Contract #: 04-0120F4Cty: SF/ALA Rte: 80 PM: 13.2/13.9File #: 69.25B**QUALITY ASSURANCE -- NON-CONFORMANCE REPORT****Location:** Changxing Island, P.R. China**Report No:** NCR-000844**Prime Contractor:** American Bridge/Fluor Enterprises, a JV**Date:** 20-Sep-2010**Submitting Contractor:** Zhenhua Port Machinery Company, Ltd (ZPMC), Changxing Island**NCR #:** ZPMC-0806**Type of problem:**

Reference Description: Heat straightening without Engineer's approval and exceeding maximum allowable temperature during heat working.

Subject: NCR No. ZPMC-0806

Contract #: 04-0120F4Cty: SF/ALA Rte: 80 PM: 13.2/13.9File #: xx.25A**QUALITY ASSURANCE -- NON-CONFORMANCE RESOLUTION****Location:** Changxing Island, P.R. China**Report No:** NCS-000776**Prime Contractor:** American Bridge/Fluor Enterprises, a JV**Date:** 13-Oct-2010**Submitting Contractor:** Zhenhua Port Machinery Company, Ltd (ZPMC), Changxing Island **NCR #:** ZPMC-0806**Type of problem:**

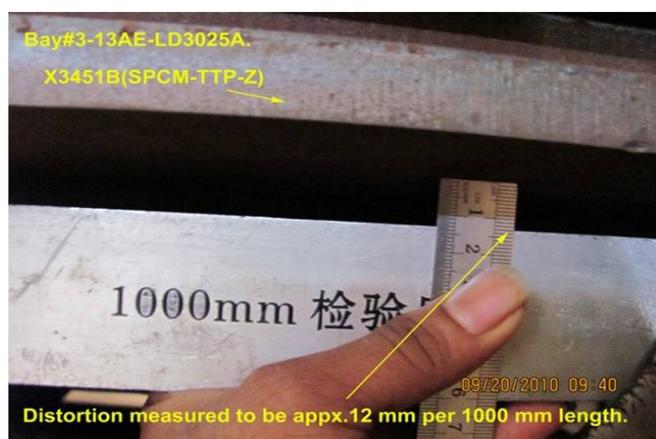
During Caltrans Quality Assurance in-process observations of the Longitudinal Diaphragm, LD3025A, fabrication, this Quality Assurance Inspector (QA) observed ZPMC personnel performing heat straightening work under the guidelines of an HSR1 when an HSR was required. Furthermore, the metal was heated above the maximum allowable temperature during heat straightening. Specific details pertaining to this incident are listed below:

- Material was heated to a bright red condition.
- This QA Inspector observed that a 760°C Tempilstik melted when struck against the heated area of the material. -A temperature indicating crayon, digital temperature measurement gauge, or other similar means of monitoring the temperature was not utilized by ZPMC Quality Control (QC) and the actual maximum attained temperature was not measured.
- The effected welds are identified as LD3025-001-083,084,177 and 178.
- These welds are Complete Joint Penetration (CJP) butt joints, joining Lifting Lug plates X3514F and X3514B (SPCM) to LD web plate X3451B (SPCM and TTP).
- The LD web plate material thickness is 18 mm.
- Distortion was measured to be approximately 12mm over a distance of 1000mm.
- ZPMC QC provided HSR1 identified as HSR1 7375 when asked for the recoding documents.
- The affected member is located in Sub assembly Bay#3.

For further information, please see the pictures below.

Caltrans Special Provisions Section 8-3: "For material more than 16 mm, the Contractor shall not heat straighten members more than 3 in 1000 without prior approval of the Engineer".

AWS 1.5 2002 section 3.7.3 "Members distorted by welding shall be straightened by mechanical means or by carefully supervised application of a limited amount of localized heat as approved by the Engineer. The temperature of the heated areas as measured by approved methods shall not exceed 600°C [1100°F] for quenched and tempered steel nor 650°C [1200°F] (a dull, red color) for other steels. The part to be heated for straightening shall be substantially free of stress and from external forces, except those stresses resulting from the mechanical straightening method used in conjunction with the application of heat."

Reference Resolution: After heating, ZPMC performed NDT and is providing the result to show the material is acceptable. Based on this ZPMC requests closure of this NCR.

ZPMC acknowledges that this piece was overheated. In the future, work crews who perform overheating will be fined in order to pay for the overheated part. This financial penalty will be a deterrent to workers performing overheating. In this case, ZPMC conducted hardness testing of the heated area (Area 1-4) and an adjacent area unaffected by overheating (Area 5) to show that the heating did not adversely affect the material hardness. After heating, ZPMC performed NDT and is providing the result to show the material is acceptable. Based on this ZPMC requests closure of this NCR.

The proposed resolution is acceptable. This NCR is considered closed.

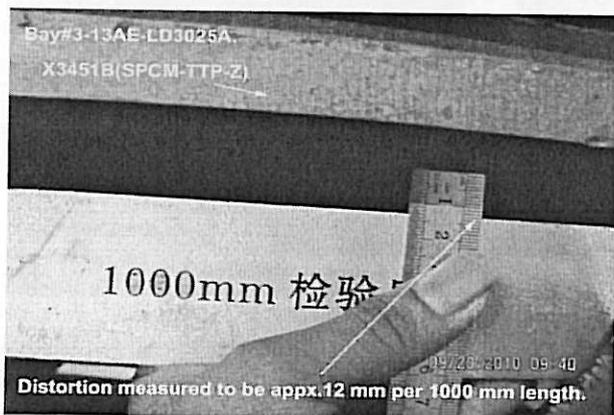
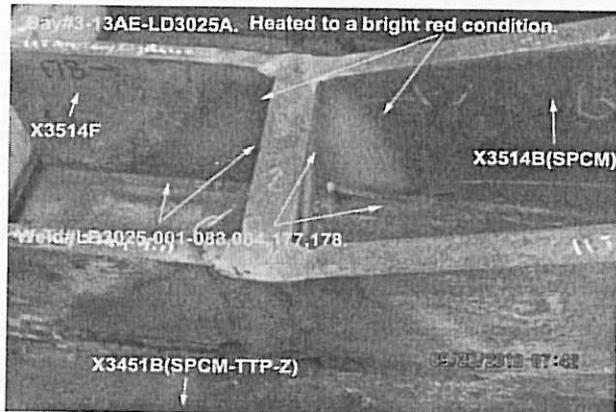
During Caltrans Quality Assurance in-process observations of the Longitudinal Diaphragm, LD3025A, fabrication, this Quality Assurance Inspector (QA) observed ZPMC personnel performing heat straightening work under the guidelines of an HSR1 when an HSR was required. Furthermore, the metal was heated above the maximum allowable temperature during heat straightening. Specific details pertaining to this incident are listed below:

- Material was heated to a bright red condition.
- This QA Inspector observed that a 760°C Tempilstik melted when struck against the heated area of the material. -A temperature indicating crayon, digital temperature measurement gauge, or other similar means of monitoring the temperature was not utilized by ZPMC Quality Control (QC) and the actual maximum attained temperature was not measured.
- The effected welds are identified as LD3025-001-083,084,177 and 178.
- These welds are Complete Joint Penetration (CJP) butt joints, joining Lifting Lug plates X3514F and X3514B (SPCM) to LD web plate X3451B (SPCM and TTP).
- The LD web plate material thickness is 18 mm.
- Distortion was measured to be approximately 12mm over a distance of 1000mm.
- ZPMC QC provided HSR1 identified as HSR1 7375 when asked for the recoding documents.
- The affected member is located in Sub assembly Bay#3.

For further information, please see the pictures below.

Caltrans Special Provisions Section 8-3: "For material more than 16 mm, the Contractor shall not heat straighten members more than 3 in 1000 without prior approval of the Engineer".

AWS 1.5 2002 section 3.7.3 "Members distorted by welding shall be straightened by mechanical means or by carefully supervised application of a limited amount of localized heat as approved by the Engineer. The temperature of the heated areas as measured by approved methods shall not exceed 600°C [1100°F] for quenched and tempered steel nor 650°C [1200°F] (a dull, red color) for other steels. The part to be heated for straightening shall be substantially free of stress and from external forces, except those stresses resulting from the mechanical straightening method used in conjunction with the application of heat."

"ZPMC acknowledges that this piece was overheated. In the future, work crews who perform overheating will be fined in order to pay for the overheated part. This financial penalty will be a deterrent to workers performing overheating. In this case, ZPMC conducted hardness testing of the heated area (Area 1-4) and an adjacent area unaffected by overheating (Area 5) to show that the heating did not adversely affect the material hardness. After heating, ZPMC performed NDT and is providing the result to show the material is acceptable."
